Project Name: Mt. Hope School – New BuildProject No.: 221125-140Architect: C2AEDate: 7/31/2023Bid Package No.: 2Bid Due Date: 08/03/2023

Addendum 3

Project No.:	22-0116	Date:	July 28, 2023
Project:	Mt. Hope Lansing School District SB-1785 Ingham County, MI	A/E Firm:	C2AE
Owner:	Lansing School District 519 West Kalamazoo Street Lansing, MI 48933	Project Manager:	Steve Jurczuk

MASONRY FRAMING PLAN - AREA A
1/8" = 1'-0"

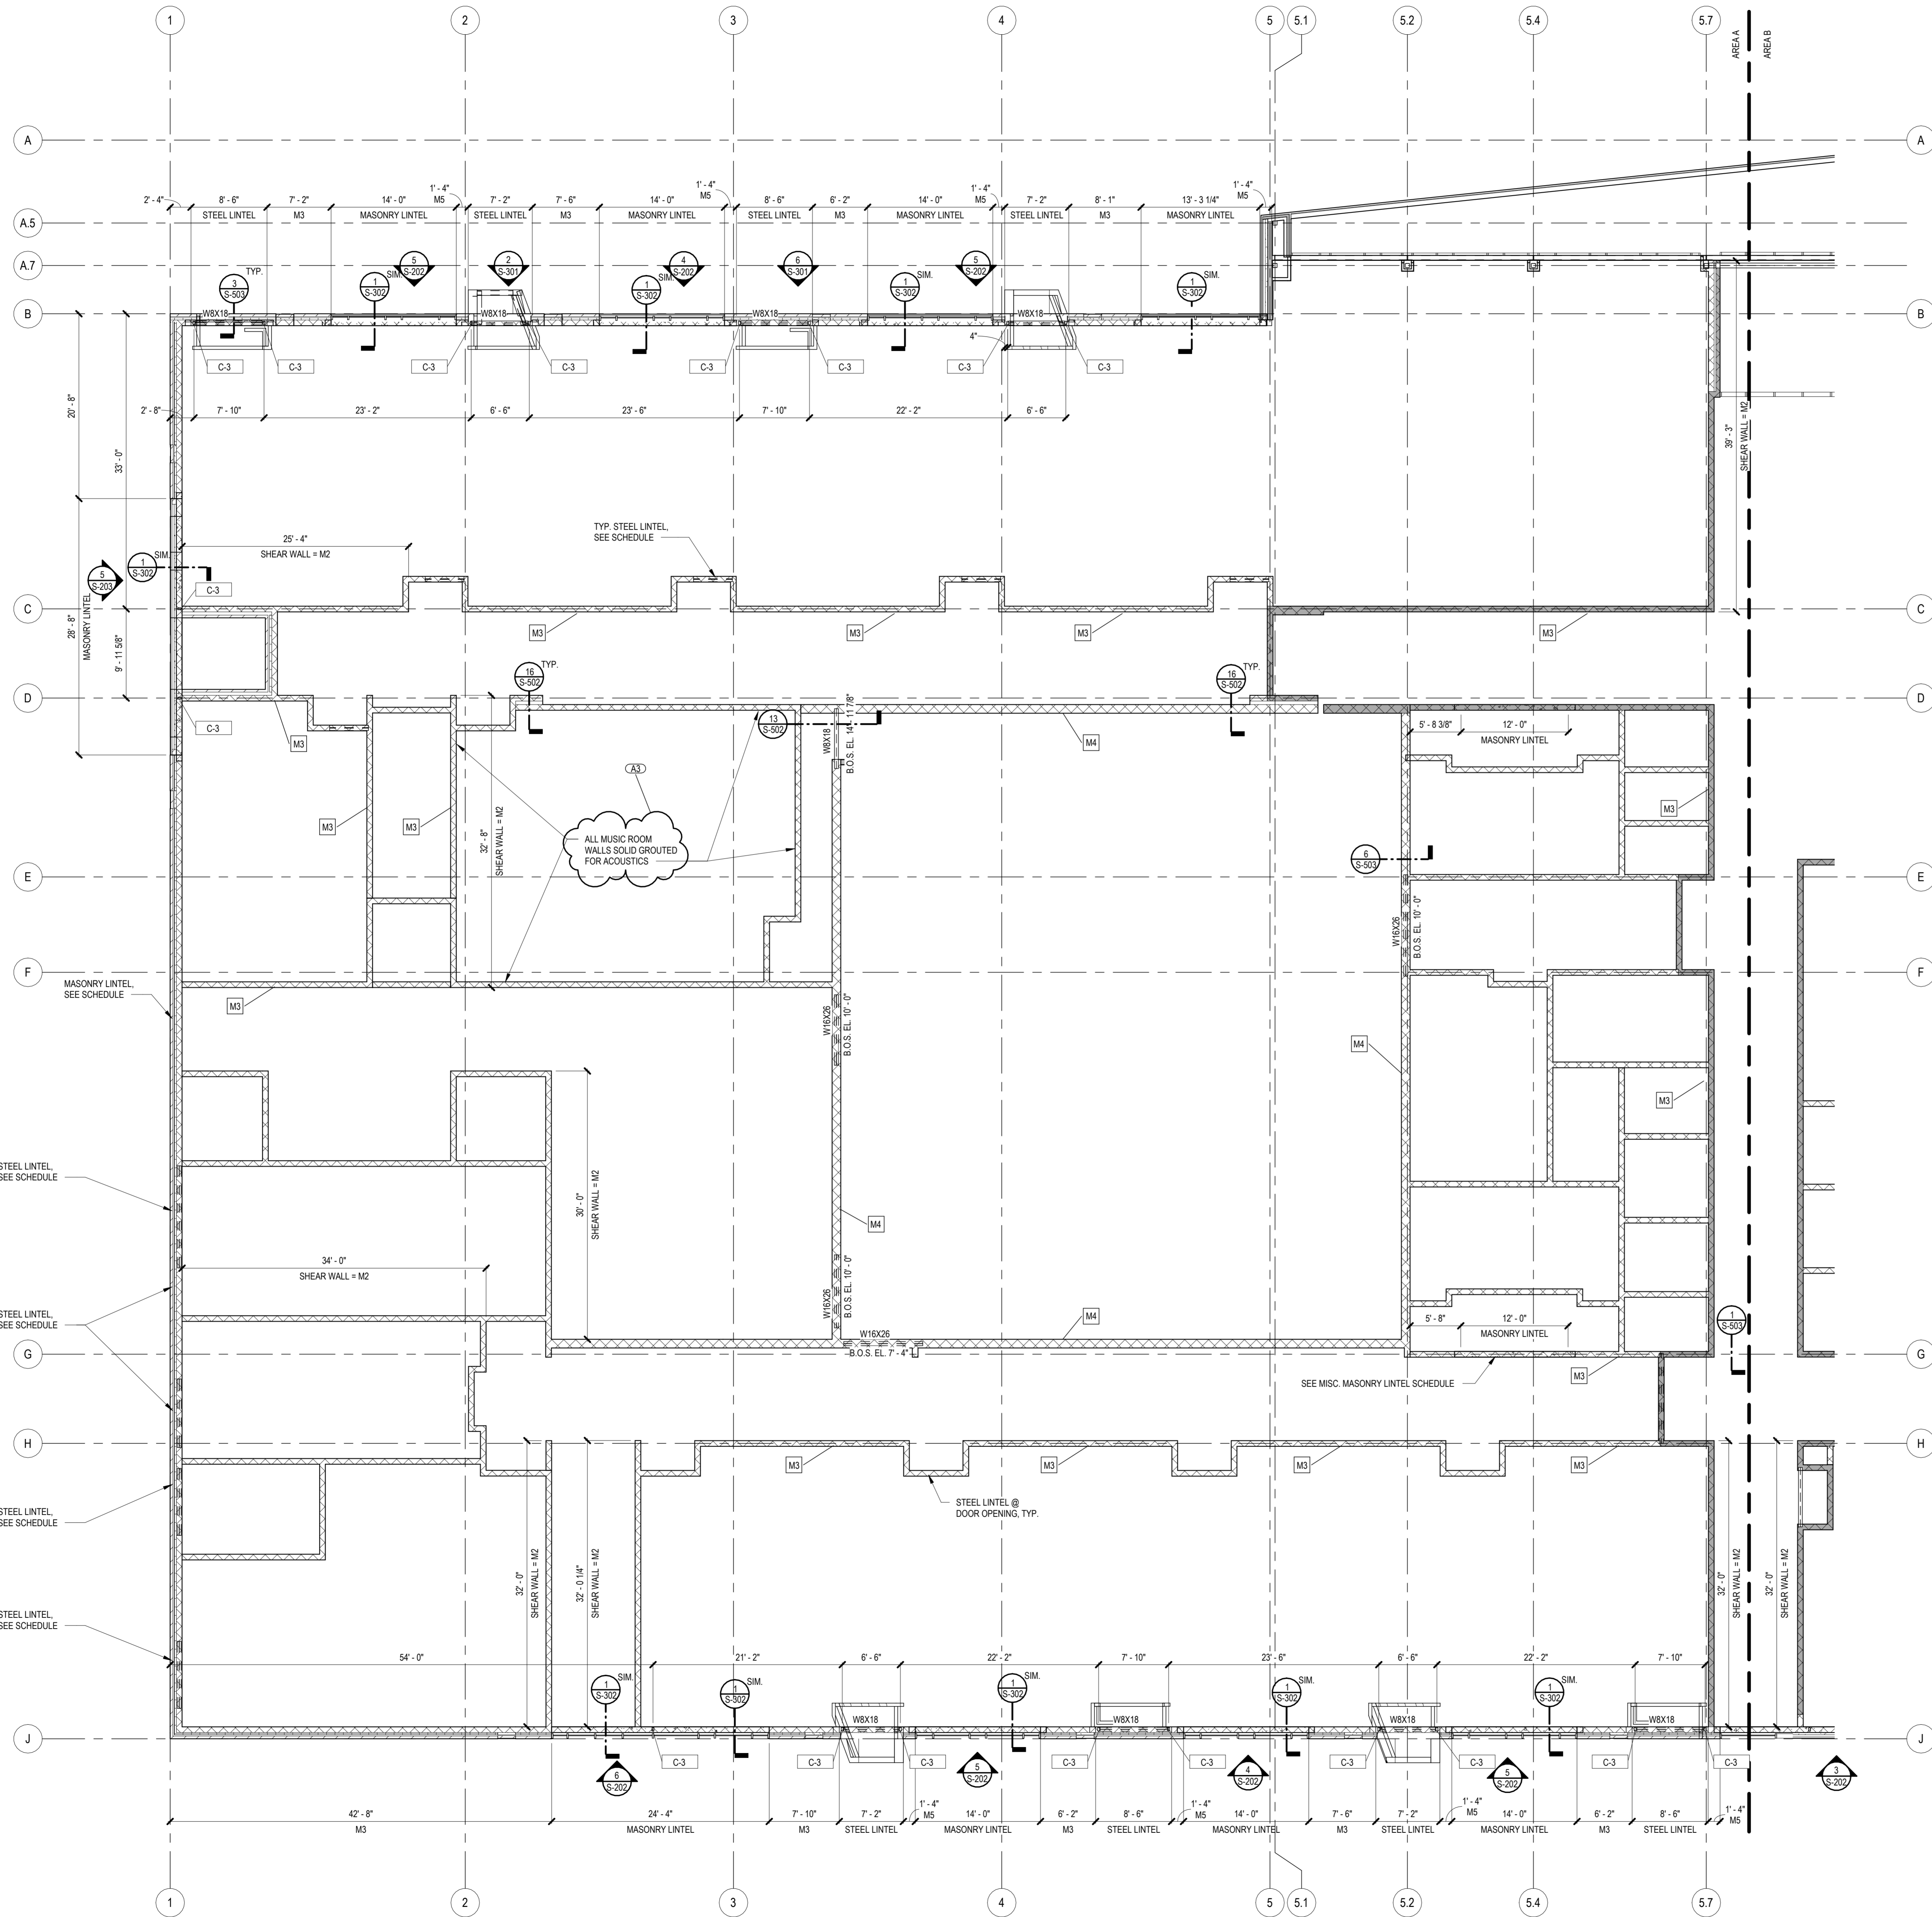
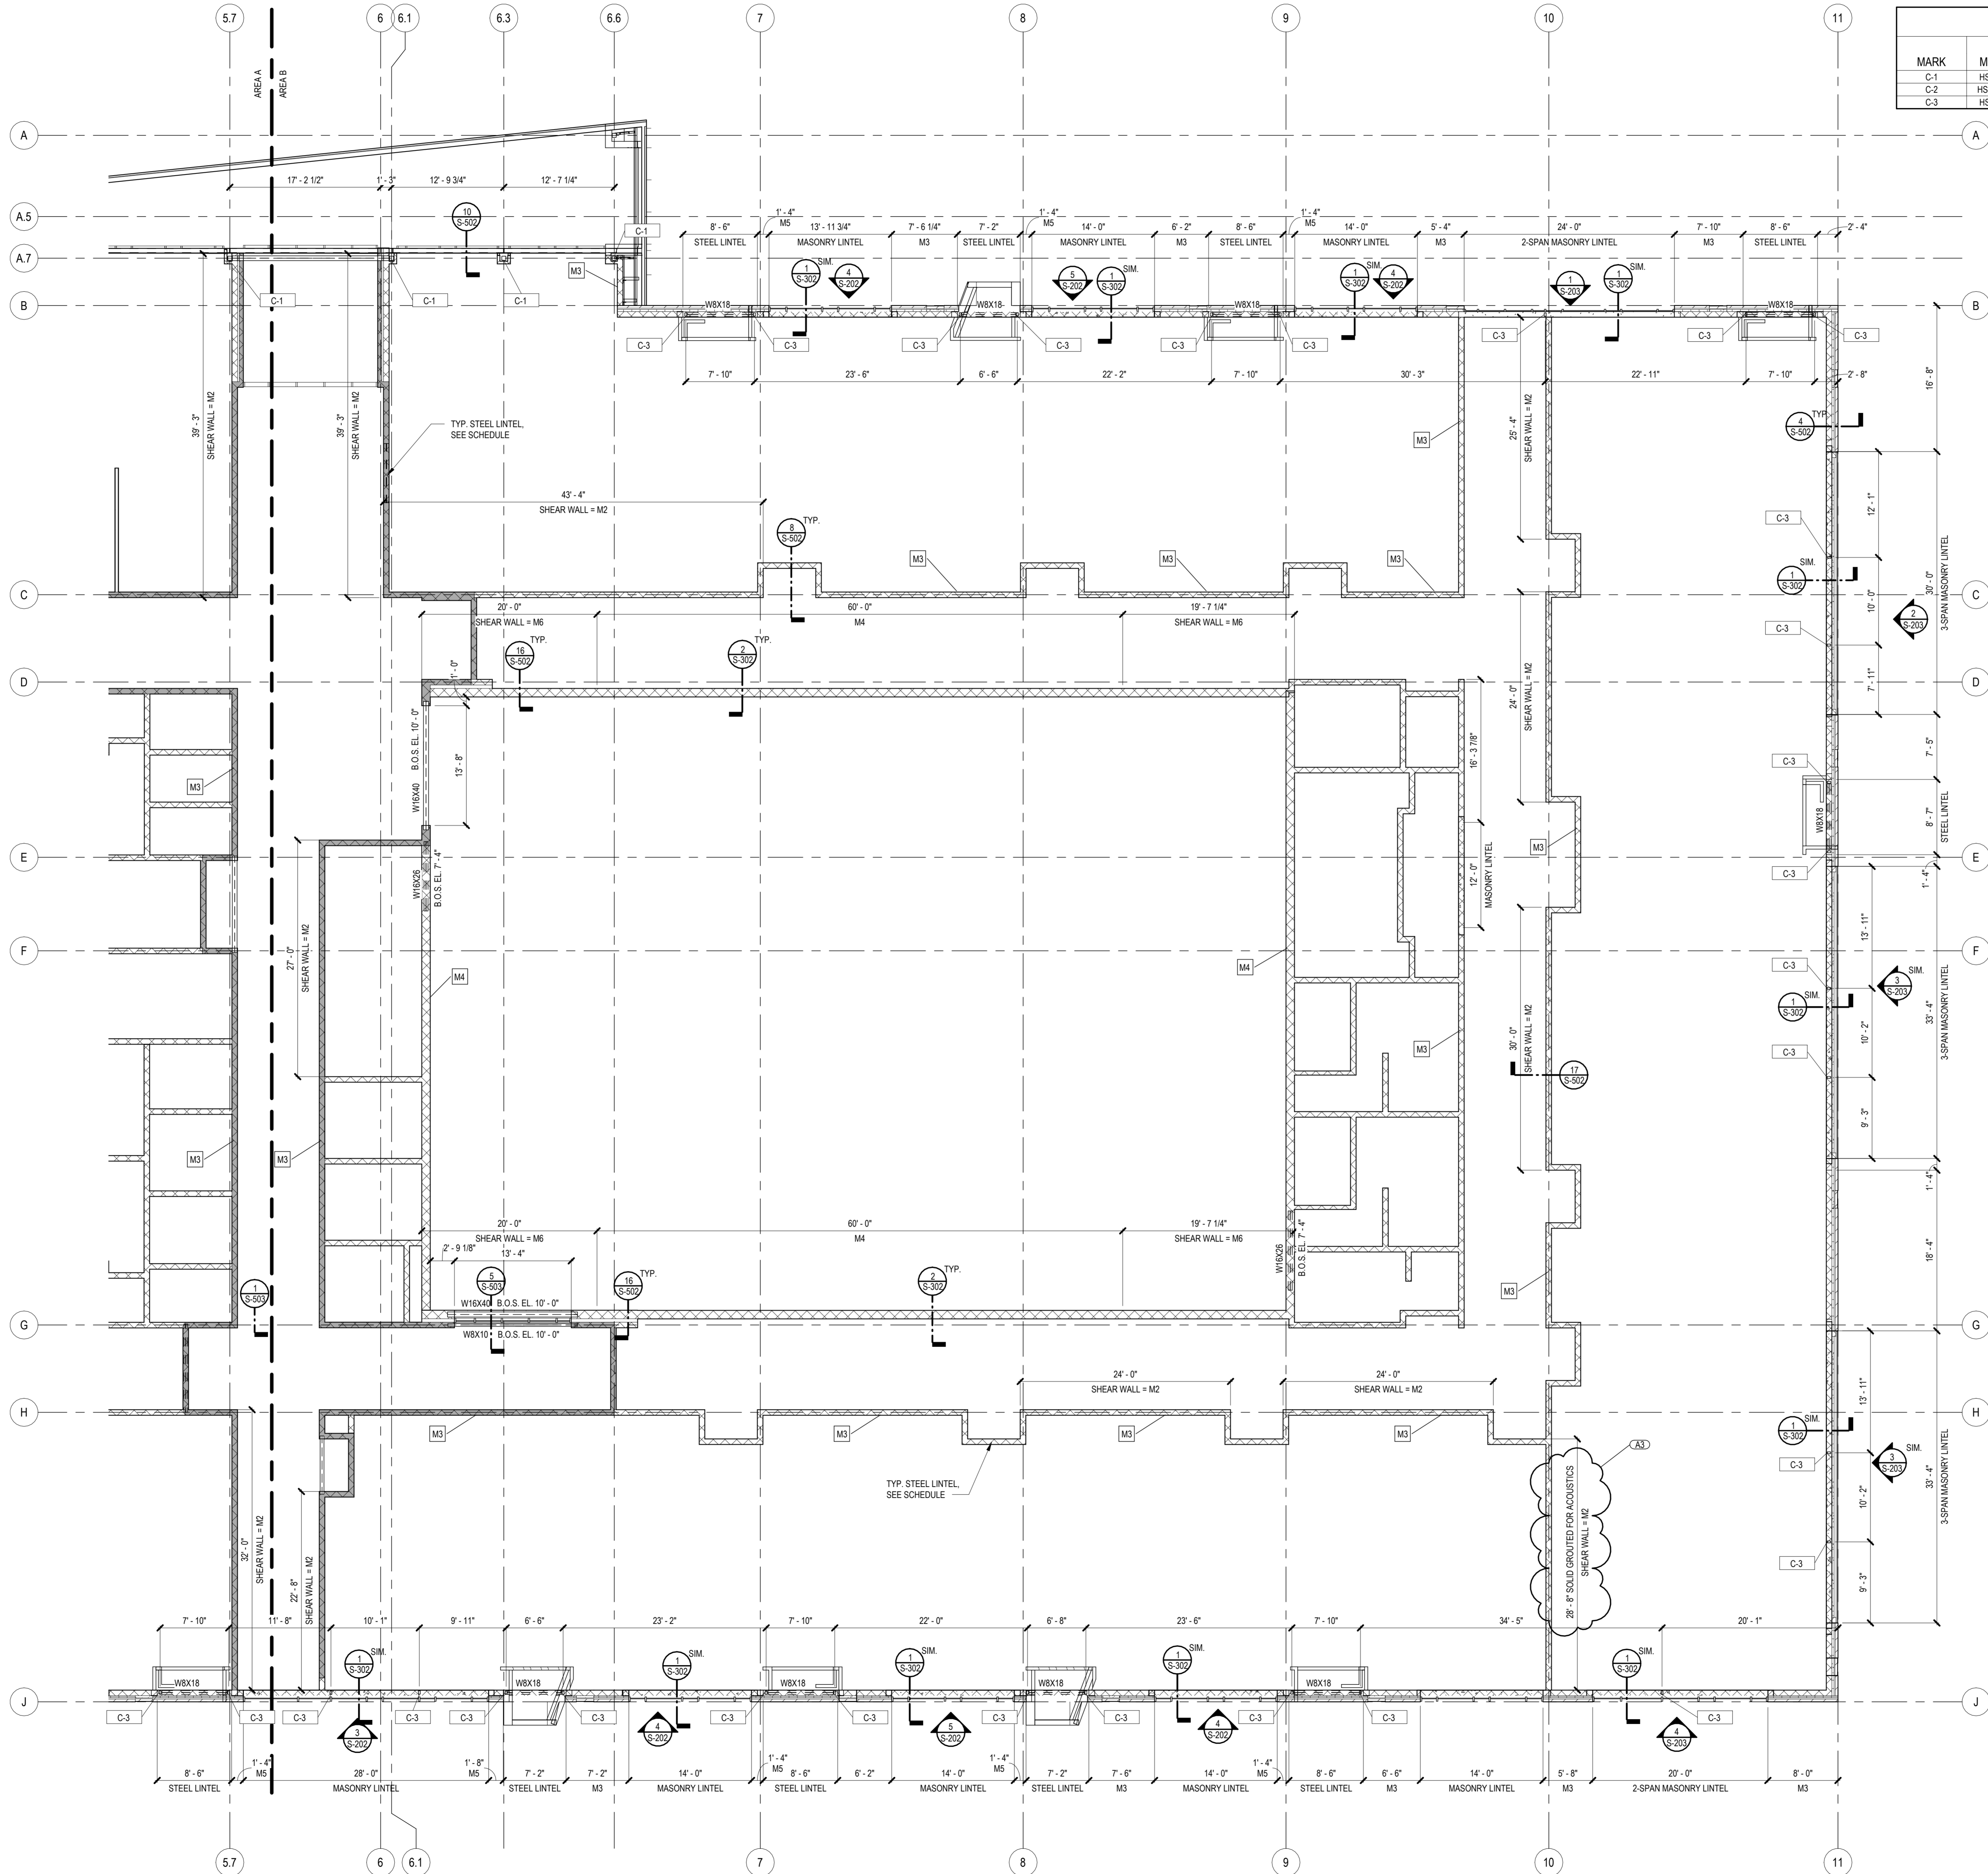
- A3.8 Refer to Sheet S-502 (reissued):
Clarify bond beam locations and elevations.
- A3.9 Refer to Sheet A-001 (reissued):
Partition type clarification.
- A3.10 Refer to Sheets A-101A, A-101B, A-121A, A-121B and A-408 (reissued):
Revise corridor locker layout and size.

22 FOOTING DETAIL FOR OUTDOOR CLASSROOM
3/4" = 1'-0"

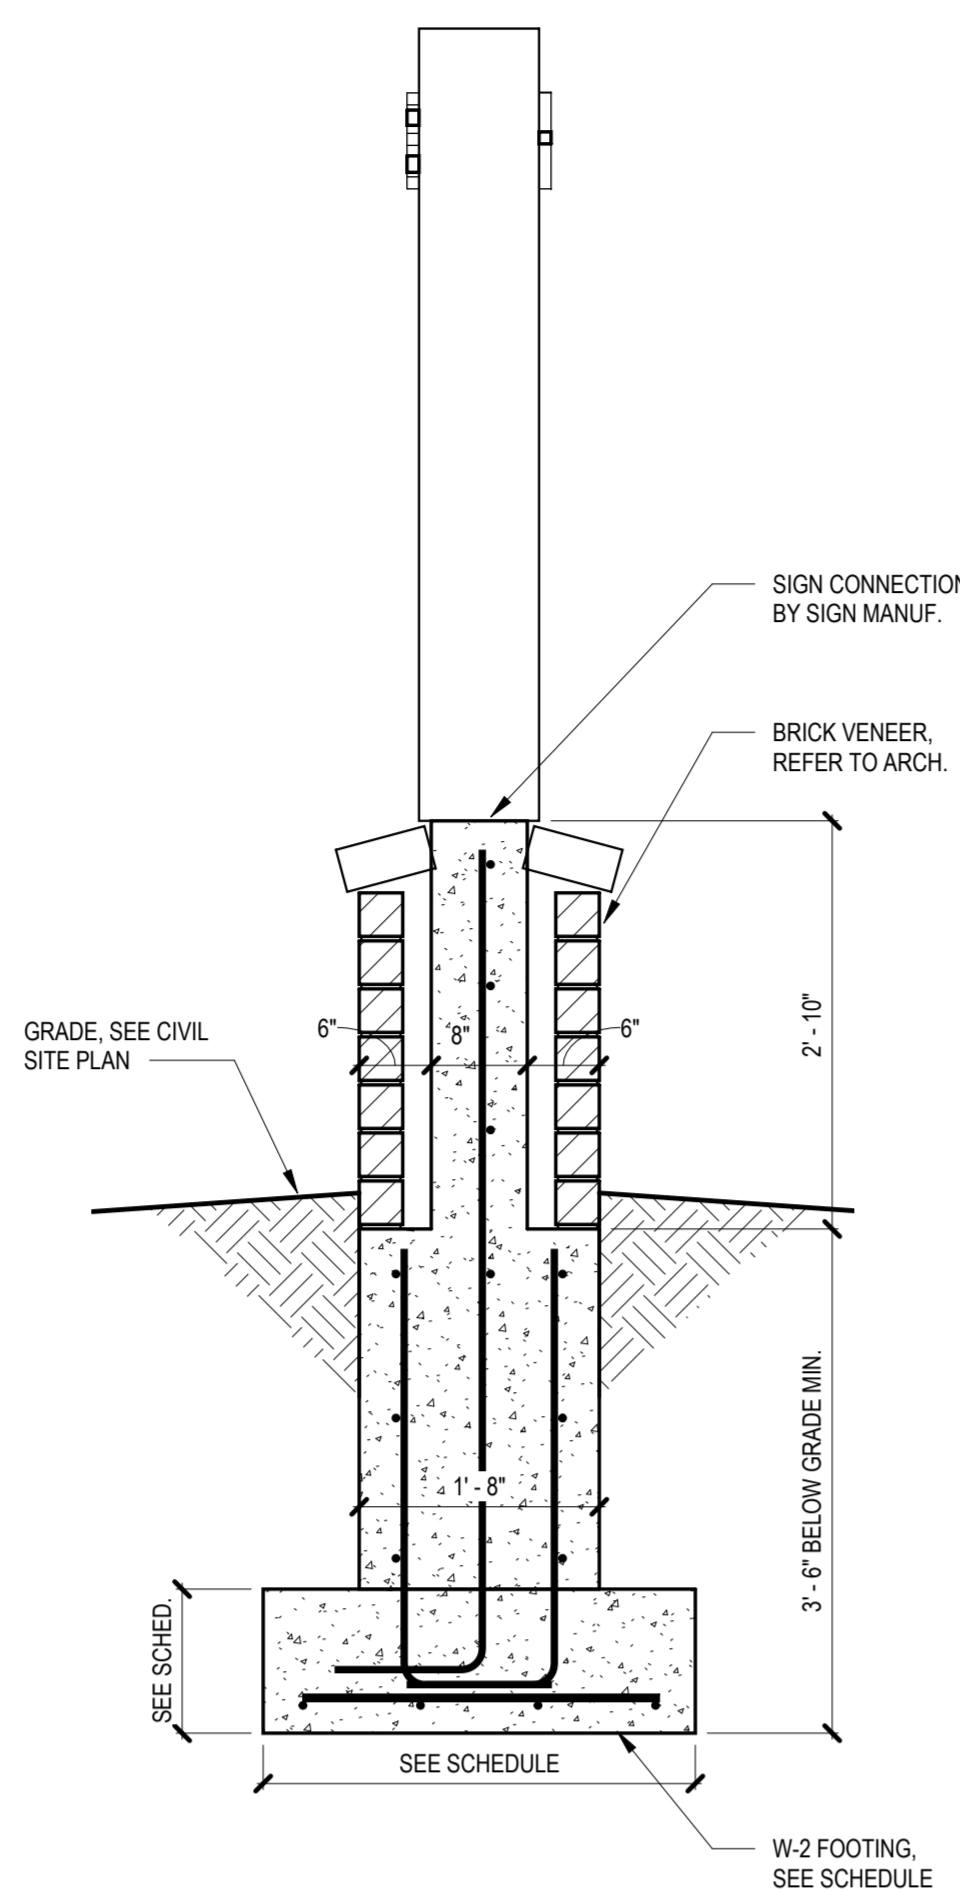
- A3.3 Refer to Sheets S-101B and S-503 (reissued):
Clarify roof deck conditions and details.
- A3.4 Refer to Sheets S-103A and S-103B (reissued):
1. Revise masonry shear wall reinforcement spacing for wall type M-2.
 2. Add notes for fully grouted CMU cores for acoustics.
 3. Clarify Masonry Wall Reinforcement Schedule Note 4.
- A3.5 Refer to Sheet S-301 (reissued):
Add notes for coordination of steel framing for reading nooks.
- A3.6 Refer to Sheet S-302 (reissued):
Revise masonry lintel connection detail to steel post.
- A3.7 Refer to Sheet S-501 (reissued):
Add typical footing for outdoor classroom pavilion structure.
